Independent Rapid Assessment of the Parramatta CBD Planning Proposal for DPE

1st March 2022

Bennett and Trimble

Aird Street Retail Area

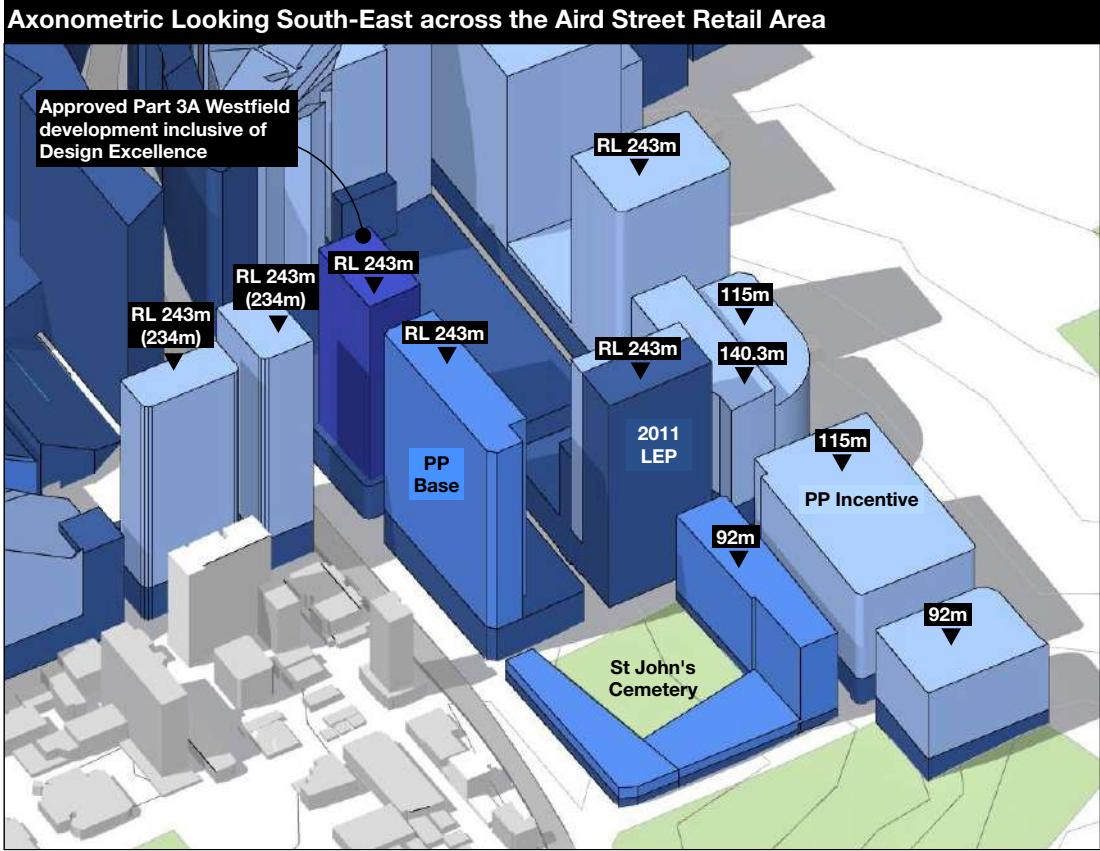
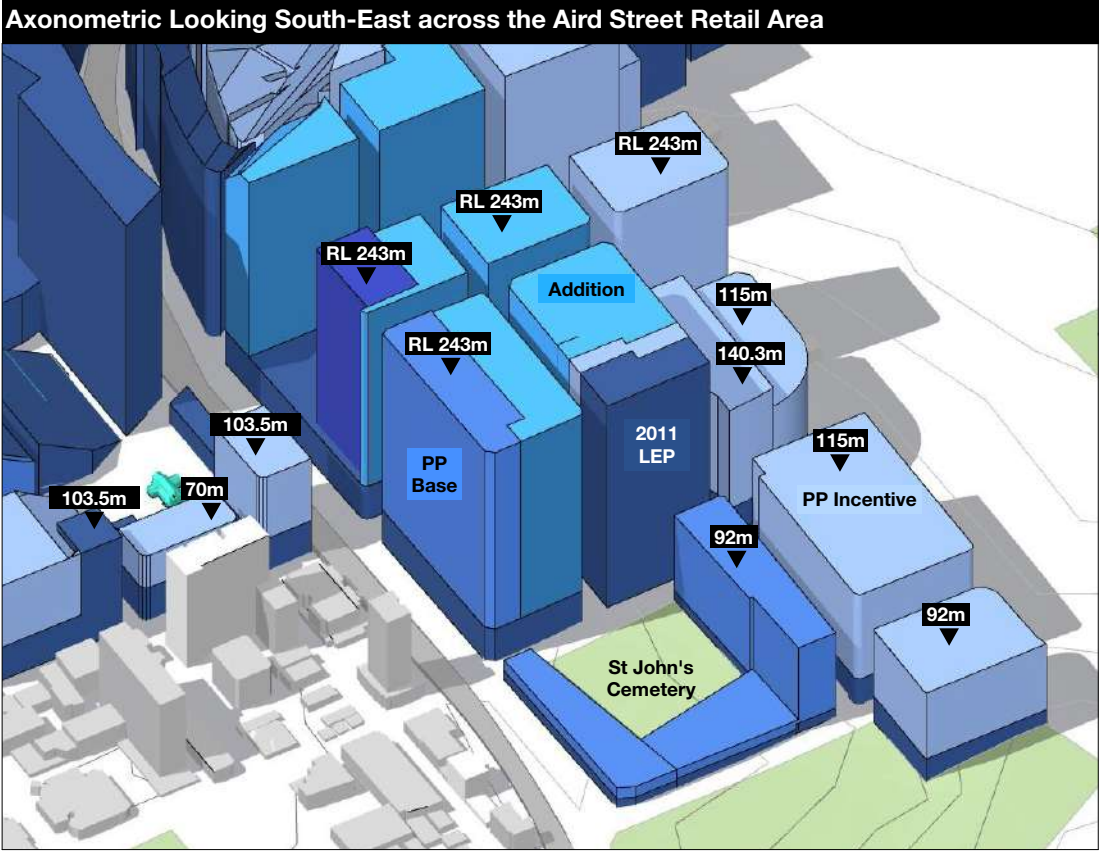
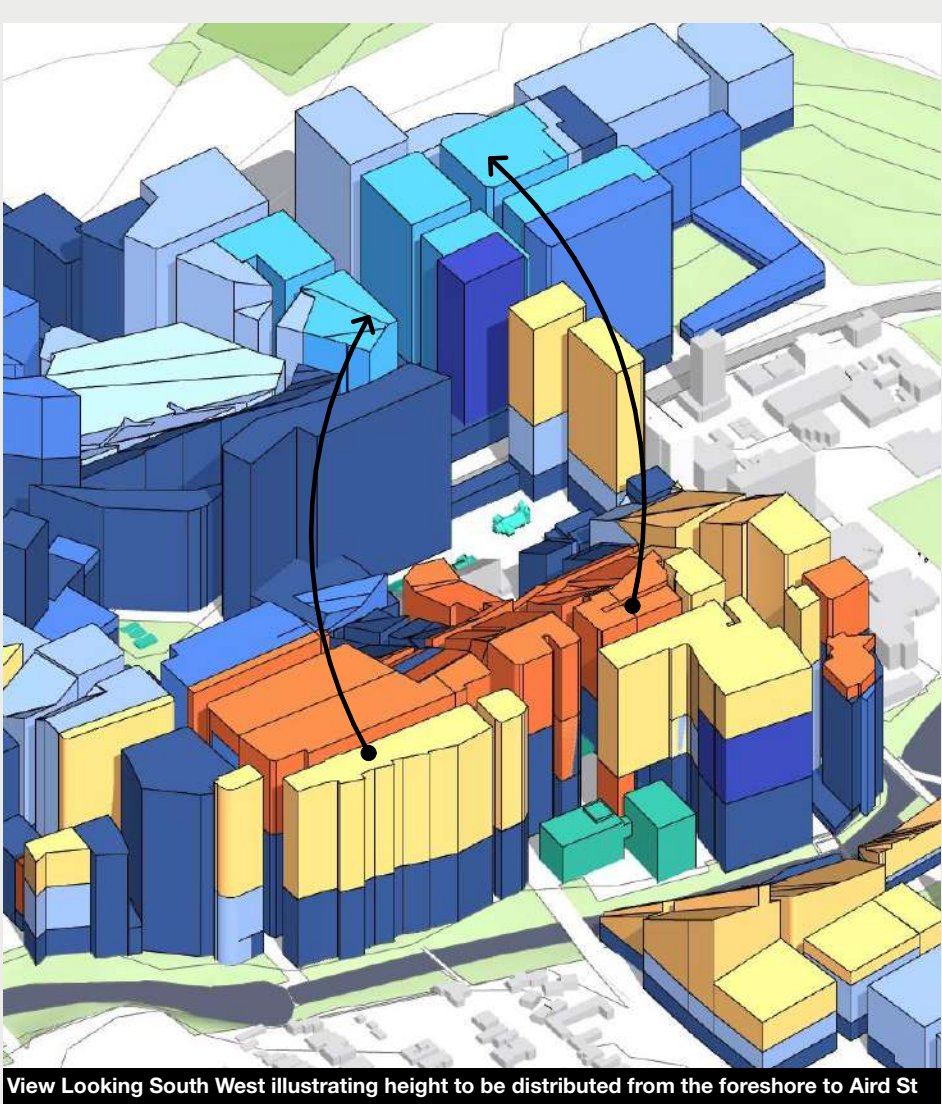
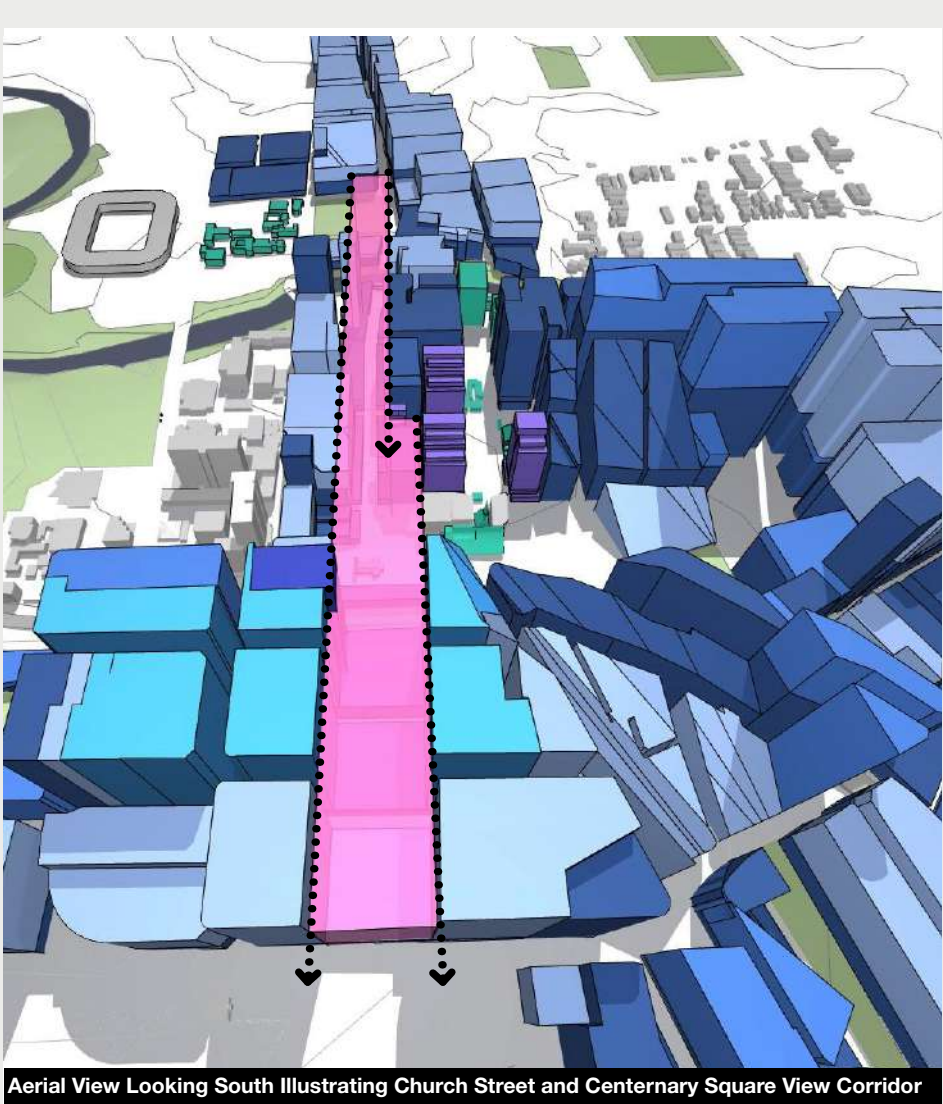
The Aird Street Retail Area, including the Westfield sites, was identified in the CBD Planning Strategy 2015 as an area to expand the B3 Commercial Core zoning. The initial version of this Planning Proposal included this recommendation but was subsequently modified to retain the Mixed-Use zoning across the majority of the area.

Substantial heights have been proposed to the north, south, east and west of this area as part of this Planning Proposal. A tower of an equivalent height was approved for the north western corner of the Westfield Site. The overshadowing impacts of these towers appears to comply with the open space solar protections outlined within the LEP and DCP.

Rezone the area as B3 Commercial Core as per the CBD Planning Strategy 2015 and the initial version of this Planning Proposal.

This increase in heights should be provided as incentives for urban renewal including the reinstatement of Aird St, improved urban connectivity and legibility, and the redevelopment of this shopping precinct as an integral and interconnected extension of the urban city structure. Detailed urban structure controls (similar to the controls developed for Aird Street) should be included within the LEP to provide greater certainty in urban outcomes.

Auto Alley Urban Interface Area

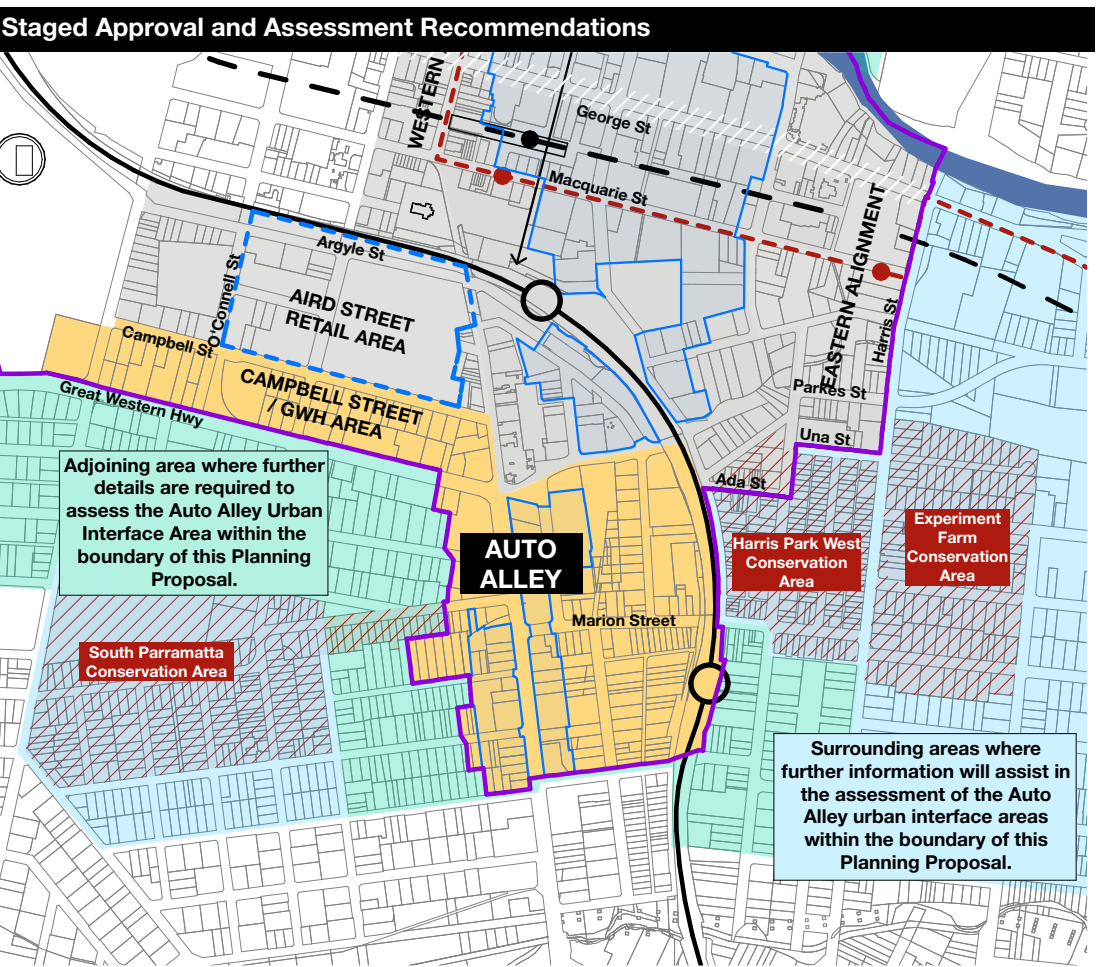
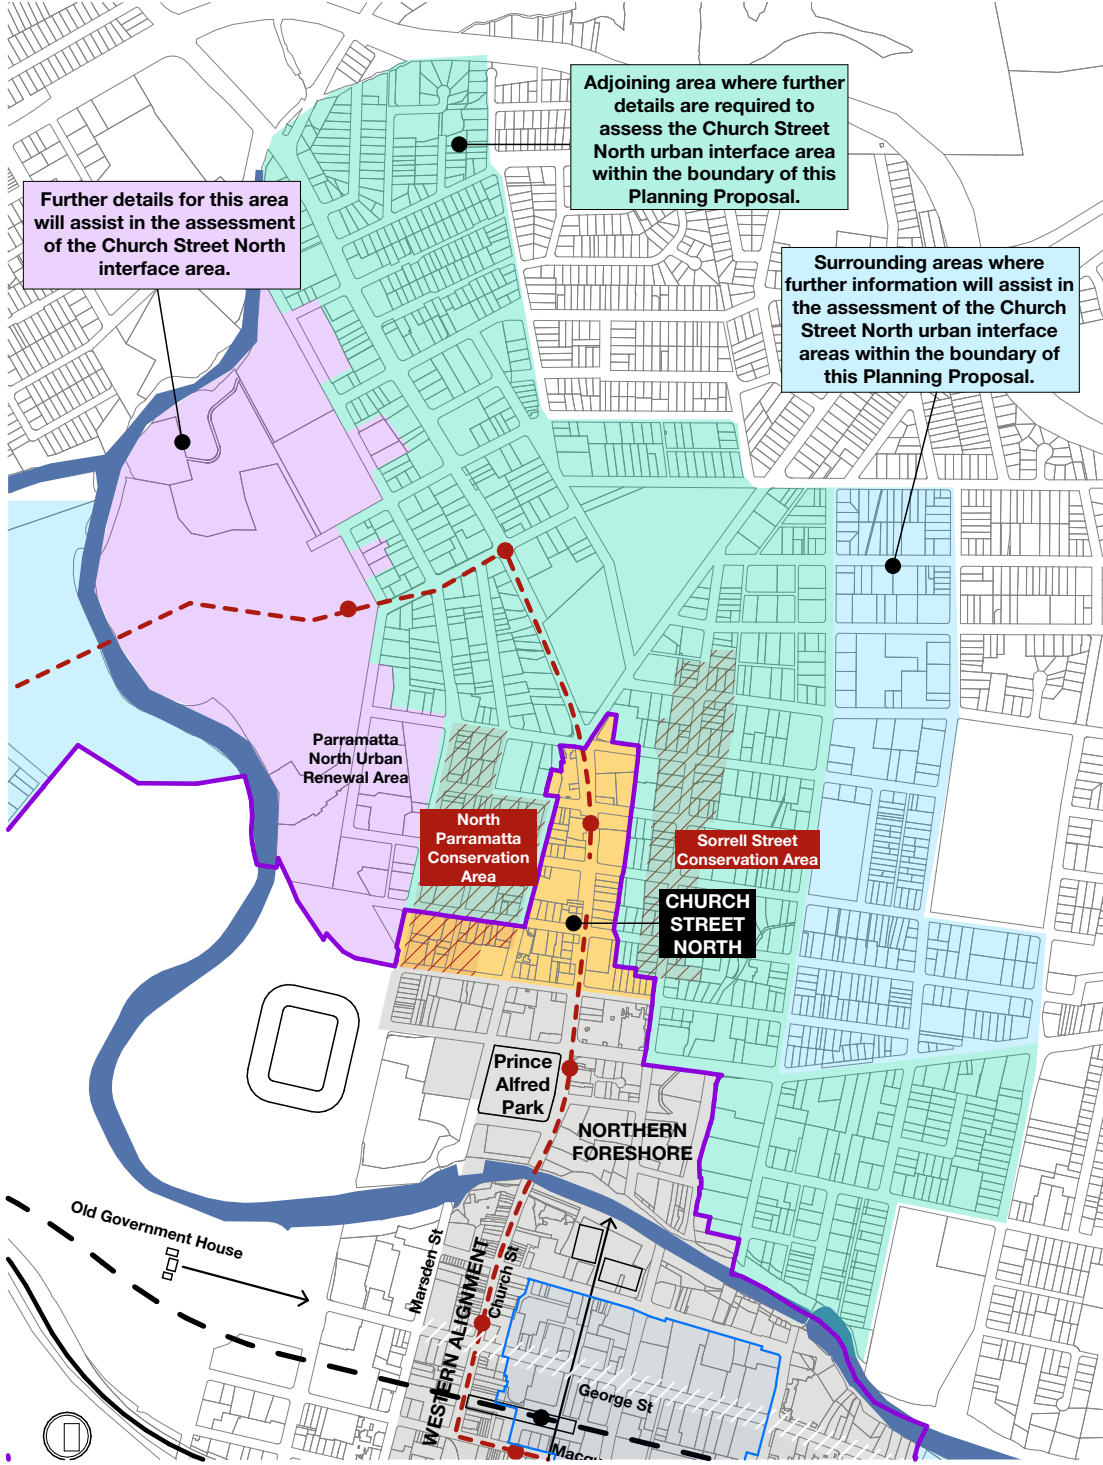
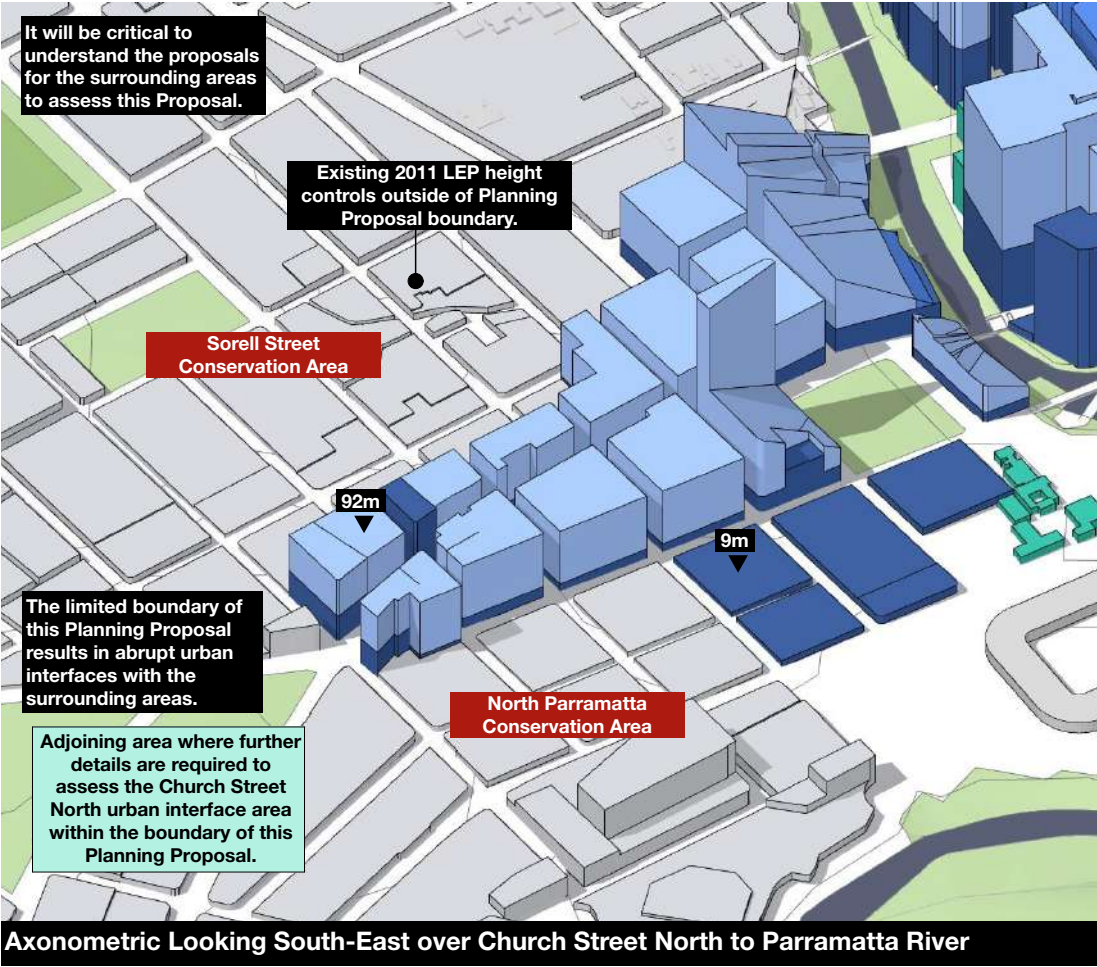
It is critical to assess these controls in relation to the controls proposed for the adjoining urban areas, particularly to the west, where they will form an important urban interface between the heights proposed for Auto Alley and low scale heritage conservation areas. It will also be important to understand wider strategies to expand and integrate the public domain and improve urban structure.

Develop planning controls for the adjoining urban areas to demonstrate a considered and integrated approach to development in the area around Auto Alley to enable an informed assessment of this Planning Proposal.

This will include understanding proposed land uses, transitions in scale and character, overshadowing impacts, wider public domain and urban initiatives, the establishment of open space networks, and consideration of a greater diversity in commercial and housing building typologies to differentiate these areas from the city centre.
